**CYPRUS PLATEAU
MINING CORPORATION**

October 17, 1997

Re: Water Monitoring Data Review, Birch Springs, Star Point Mine, Cyprus Plateau Mining Corporation, ACT/007/006, Folder #3, Carbon County, Utah

Figure AA-1A
Birch Spring Historic Flow

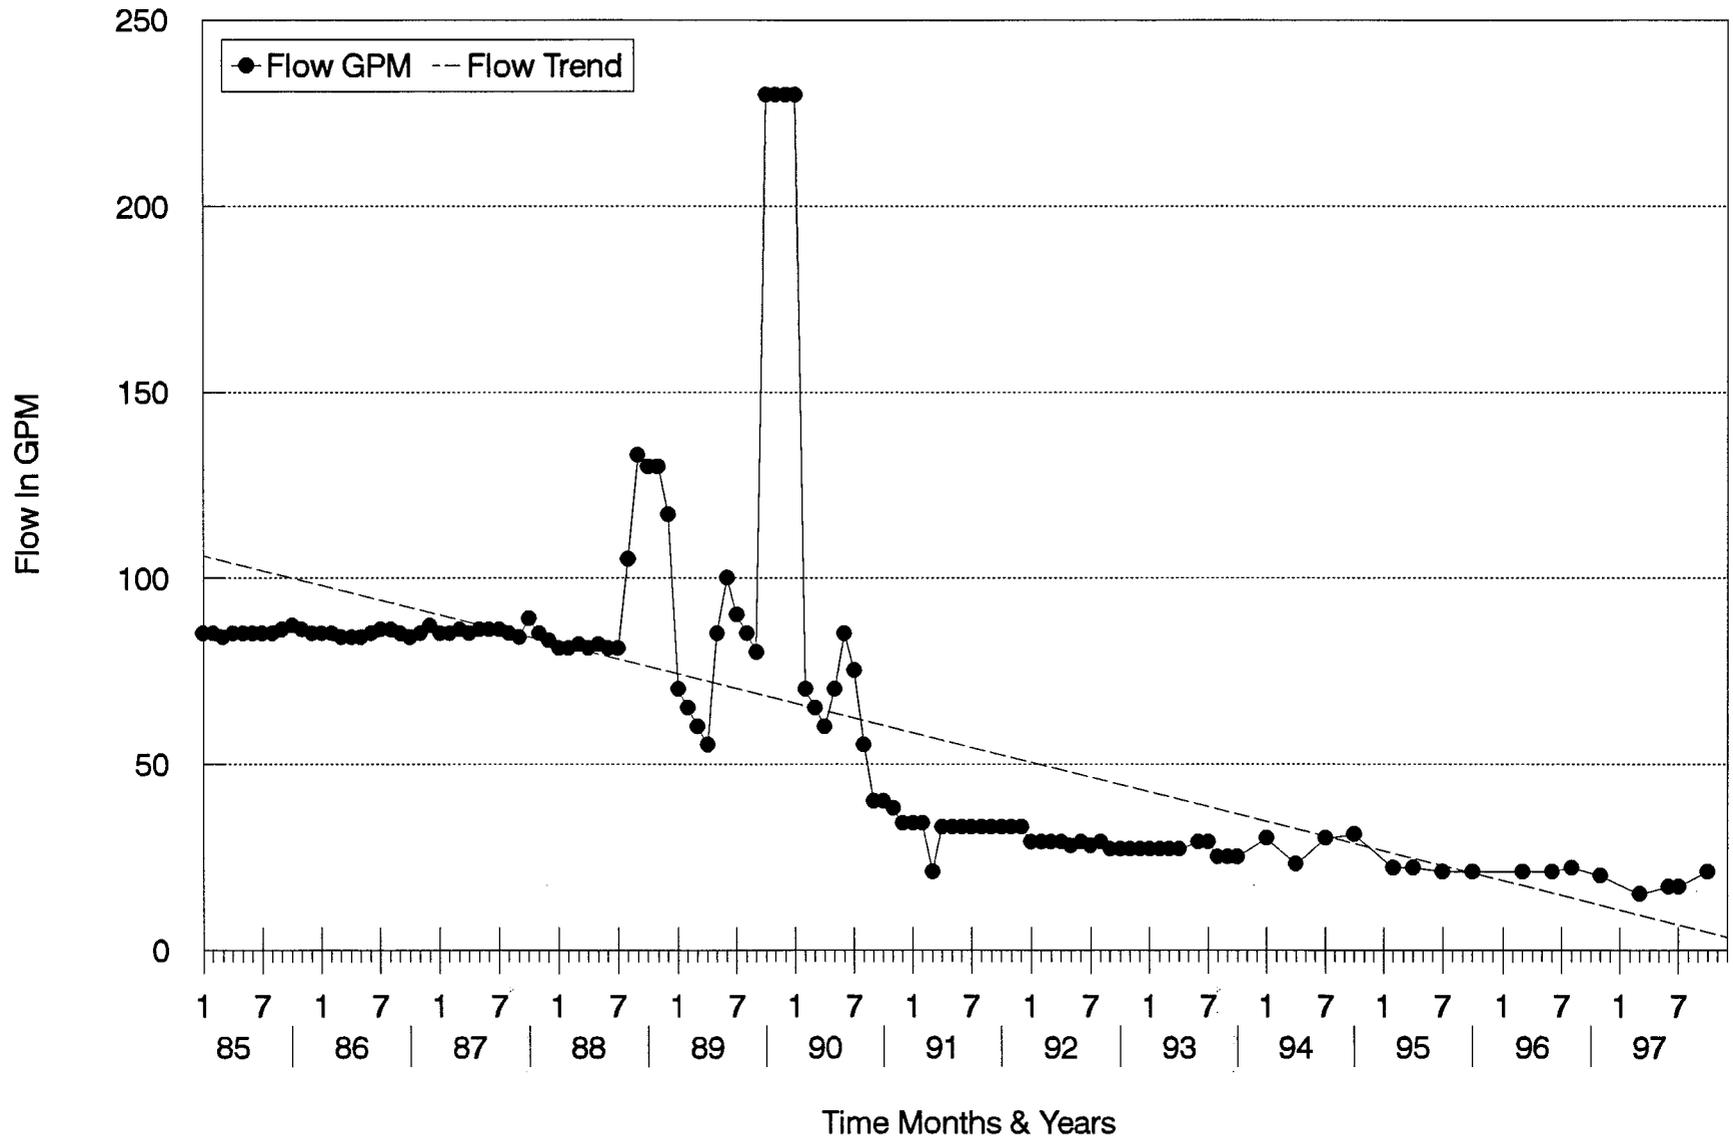
I have enclosed a copy of Figure AA-1A showing the Birch Spring Historic Flow along with the monitoring data. It should be noted that CPMC did not start monitoring Birch Spring until 1993, as presented in CPMC's 1993 Annual Hydrology Monitoring Report, and that all data prior to 1993 was obtained by Mr. Ben Grimes (CPMC's Sr. Staff Project Engineer) from the North Emery Water Users when he was president of the water users.

The flow plot for Birch Spring shows a similar trend to that of the Tie Fork wells (Figure 26-A and Tie Fork Well Flow Chart) through June of 1992. The flows were fairly constant prior to August of 1988, on the order of 85 gpm. In August of 1988, following the earthquake, the flow in the spring increased significantly. Since the increase in flows in August of 1988, the flows in Birch Spring has generally declined, with one fairly significant exception that occurred in October 1989, wherein the flow was nearly triple that of pre-1988 levels for a short four-month period.

Figure 26-A
86-35-2-3 Historic Flow

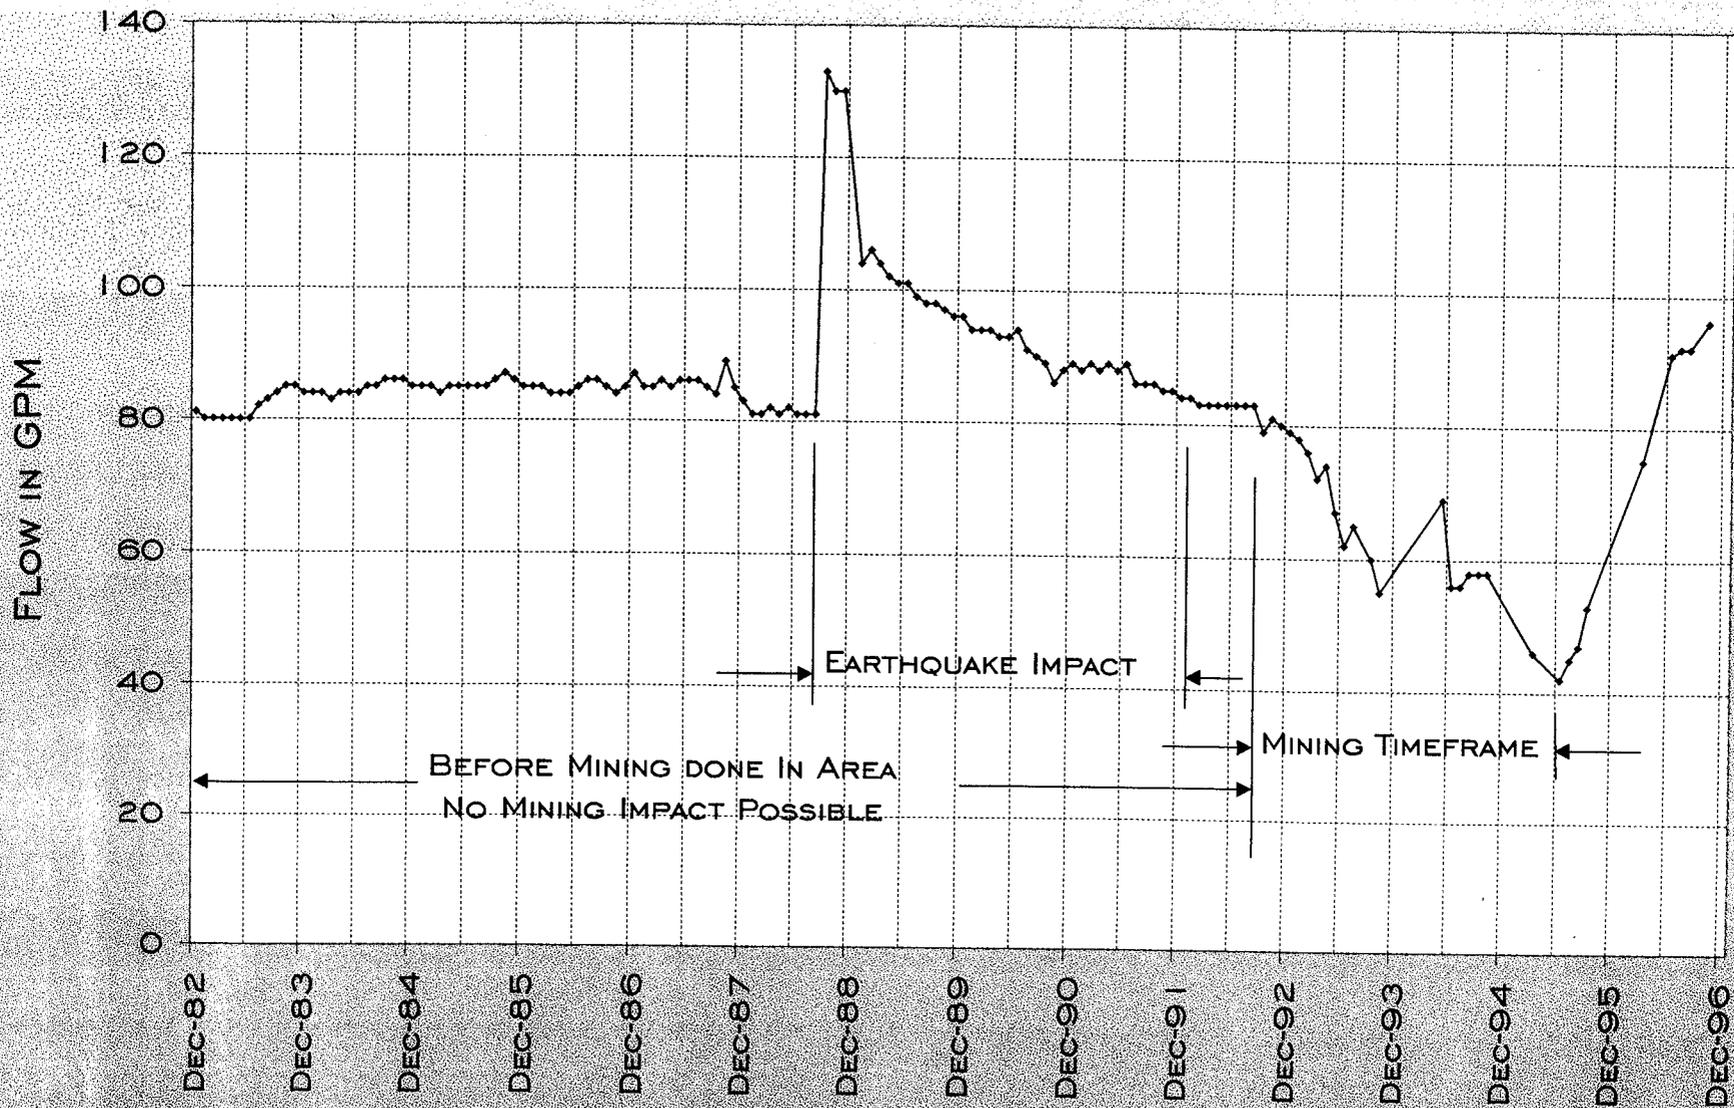
The Tie Fork Well Flow Chart and Figure 26-A show the flow pattern prior to mining, during and following the earthquake, during mining beneath Gentry Ridge, and post mining of the Gentry Ridge. Shortly after mining ceased under Gentry Ridge, flows increased and continue to increase at the Tie Fork Well.
